ARCHITECTURAL REVIEW BOARD MEETING
CITY HALL, 385 SOUTH GOLIAD STREET, ROCKWALL, TEXAS
APRIL 29, 2025 IN THE CITY COUNCIL CONFERENCE ROOM AT 5:00 PM

PROJECT COMMENTS

PROJECT NUMBER: SP2025-014
PROJECT NAME: Site Plan for a Retail/Office Building
SITE ADDRESS/LOCATIONS: 2351 HARBOR HEIGHTS DR

04/24/2025: SP2025-014 Site Plan for 2351 Harbor Heights Drive

Sheet Title:
SITE PLAN -
ELECTRICAL
LIGHTING

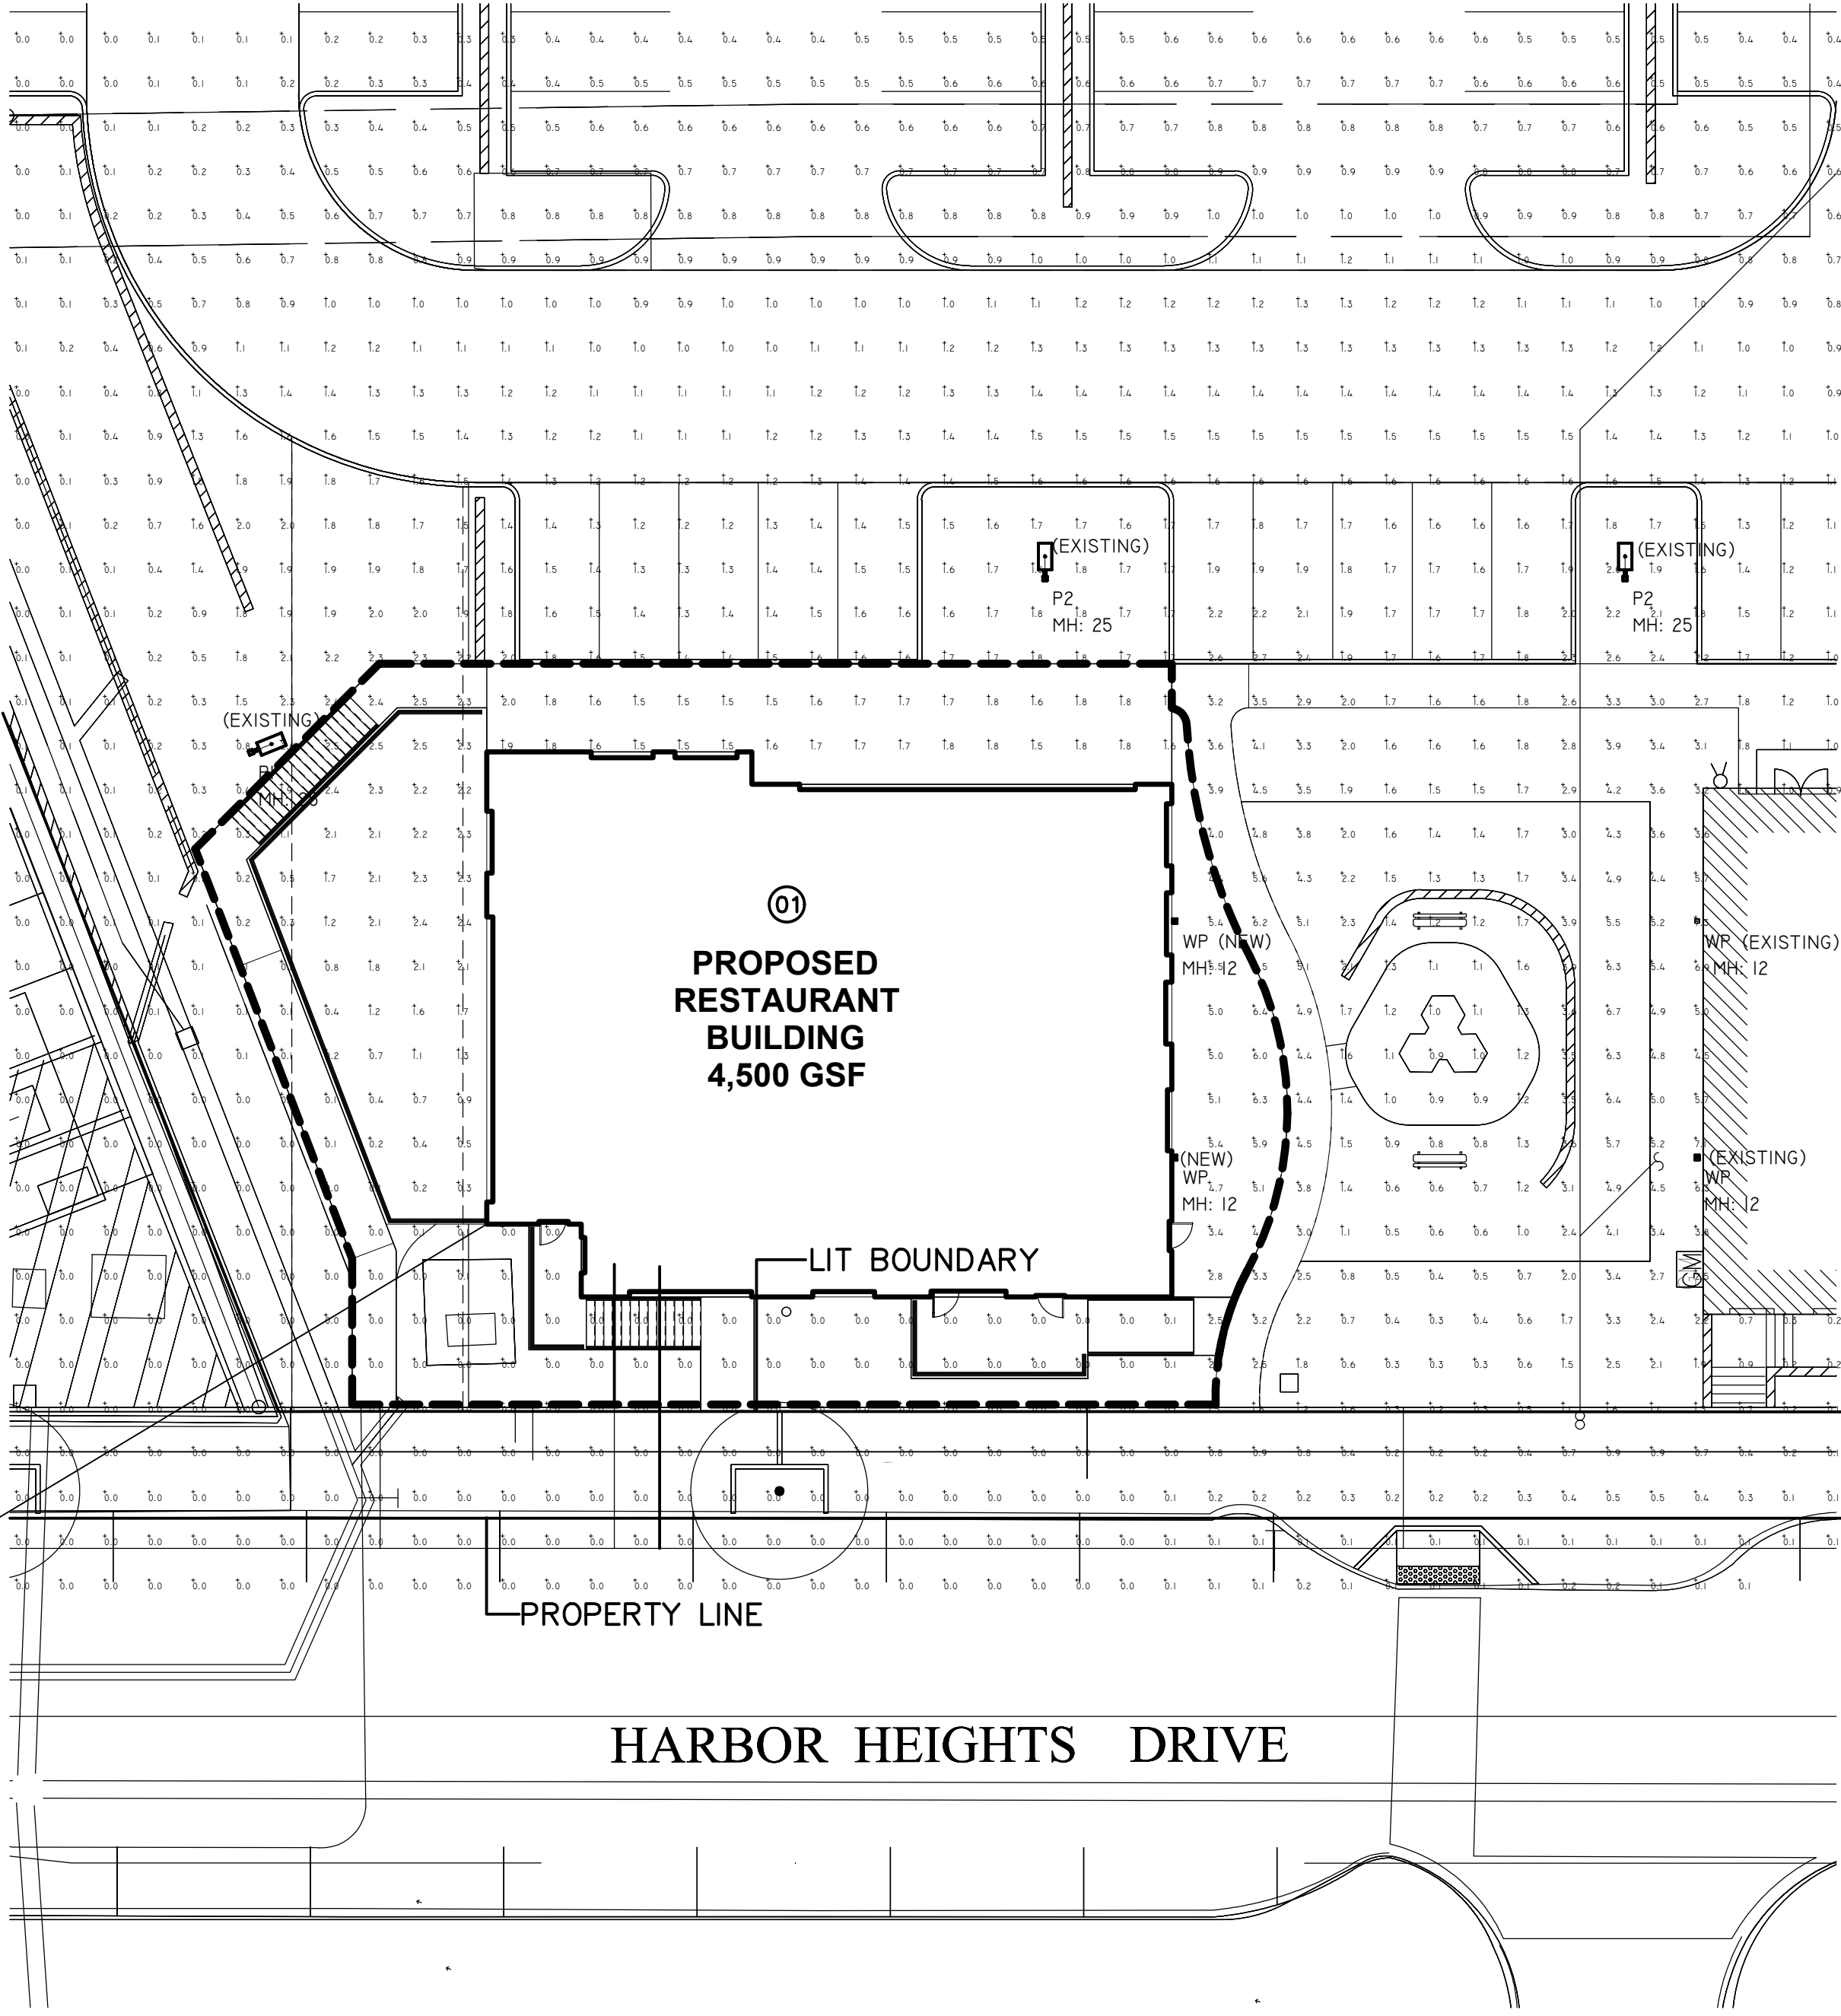
(1) The allowable maximum light intensity measured at the property line of a non-residential property shall be 0.2 of one-foot candle. (Subsection 3.03.C, of Article 07, of the UDC)

(2) Please provide lighting cut sheets that indicate the wattage for each exterior lighting fixture. Light sources (e.g. light bulbs) shall be oriented down and toward the center of the site or shielded so as to not be visible from the property line. (Subsection 03.03.A, of Article 07, of the UDC)
